Subject: Duke Energy Carolinas, LLC  
Oconee Nuclear Station (ONS), Units 1, 2, and 3  
Docket Numbers 50-269, 50-270, and 50-287  
Renewed Operating License Numbers DPR-38, DPR-47, and DPR-55  
Response to Request for Additional Information (RAI) regarding License  
Amendment Request to Update Pressure-Temperature Limit Curves  
License Amendment Request (LAR) No. 2012-10, Supplement 1

ANP-3127Q1NP

**Response to NRC Request for Additional  
Information Regarding License Amendment  
Request to Update Pressure-Temperature  
Limit Curves for Oconee Units 1, 2, and 3**

**Figure 2.1.2-1 Composite Heatup P-T Curve for Oconee Unit 1 (Adjusted Figure 7-1 of ANP-3127)**

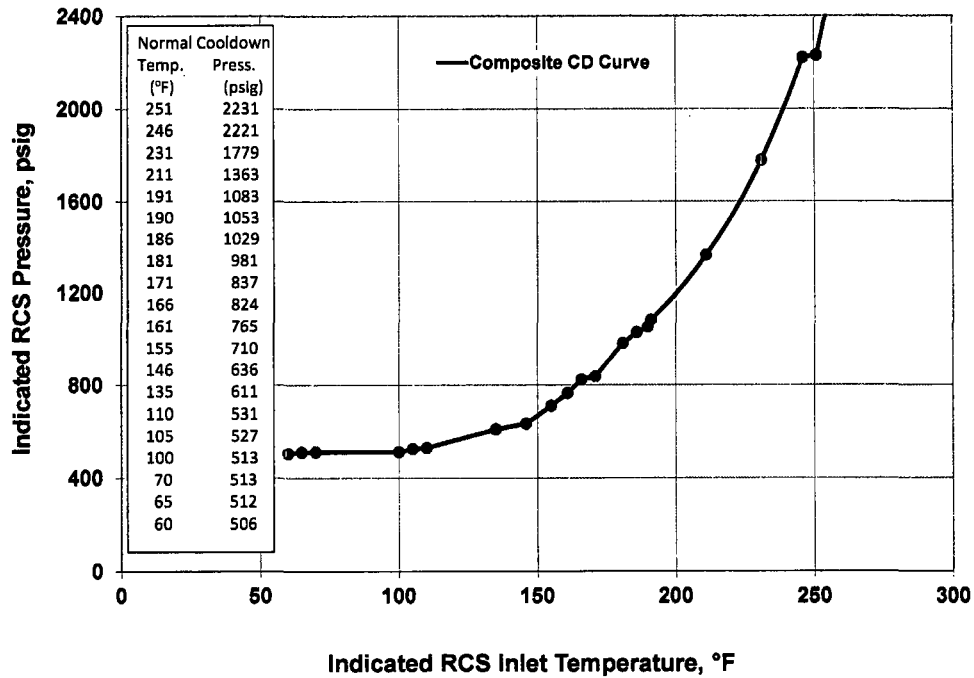
- Using a proposed composite heatup curve and a proposed cooldown curve as examples, point out the segments that were limited by closure head, outer nozzle, and beltline.
- Confirm availability of material data (initial  $RT_{NDT}$  and copper and nickel contents) for all non-beltline materials for all three unit RPVs and demonstrate that none of them will become limiting under the 54 EFPY fluence.
- Confirm that the lowest service temperatures (LSTs) for all Ferritic RCPB components that are not part of the RV have been established for all three Oconee units, and the lowest temperature of 60 °F in the proposed P-T limits are higher than these LSTs.

from the beltline region is the controlling segment due to the high adjusted reference temperatures of the beltline axial welds, as shown in the heatup and cooldown curves provided below for Oconee Unit 1. Only the portion of the heat up curve ranging from [ ] to [ ] °F is governed by the closure head flange region (as illustrated in Figure 2.1.2-1), while the entire cooldown curve of Figure 2.1.2-2 is controlled by the beltline axial welds. It is noted that the heatup curve between [ ] and [ ] °F is forced to be horizontal (flat) to avoid a negative slope when the reactor coolant pump starts at 170 °F.

Figure 2.2.2-1 RPV Configuration for Oconee Unit 1

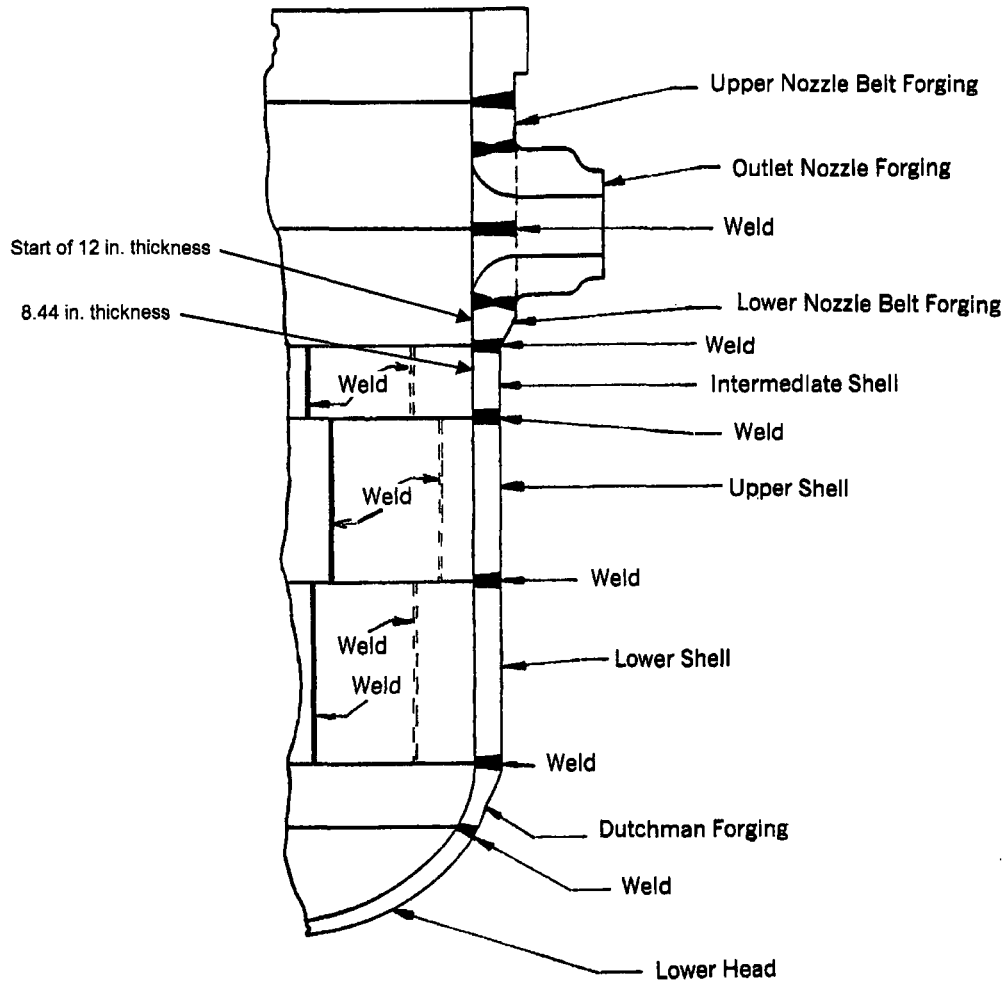
The fluence values at the one-quarter thickness (1/4T) and 3/4T of the RV in Table 3-1 of ANP-3127, Revision 1 (the ANP, Enclosure 2 of the February 22, 2013, submittal) appear to be not based on the same RV thickness for the same unit. Please confirm that you used Equation (3) in Regulatory Guide (RG) 1.99, Revision 2, "Radiation Embrittlement of Reactor Vessel Materials," to calculate the fluence at 1/4T and 3/4T of the RV. Please also provide the values that you used for "x" in Equation (3) in the ART calculations at 1/4T and 3/4T for the limiting materials shown in Table 3-1 and the RV radius that you used in the P-T limit calculations. Provide the same information for Units 2 and 3.

The neutron fluence values at the 1/4T and 3/4T vessel wall locations were calculated in accordance with Equation 3 of Regulatory Guide 1.99, Revision 2<sup>8</sup>. For Oconee Units 1, 2 and 3 a minimum wall thickness of 8.44 inches was used for the reactor vessel beltline regions with a minimum cladding thickness of [ ] inches. The lower nozzle belt forgings vary in thickness from a minimum thickness of 8.44 inches to 12.0 inches with a minimum cladding thickness of [ ] inches. These wall thicknesses are depicted in Figure 2.2.2-1 and Figure 2.2.2-2. Based on the increase in thickness of the lower nozzle belt forgings, the depth into the wall measured from the inner (wetted) surface, "x", was calculated for the two (2) thicknesses:

The reactor vessel beltline inner radius used in the P-T limit calculations, 85- $\frac{1}{2}$  inches, is based on the vessel shell inner diameter equal to 171 inches. The nozzle belt inner radius used in the P-T limit calculations is [  $\quad$  ] inches.
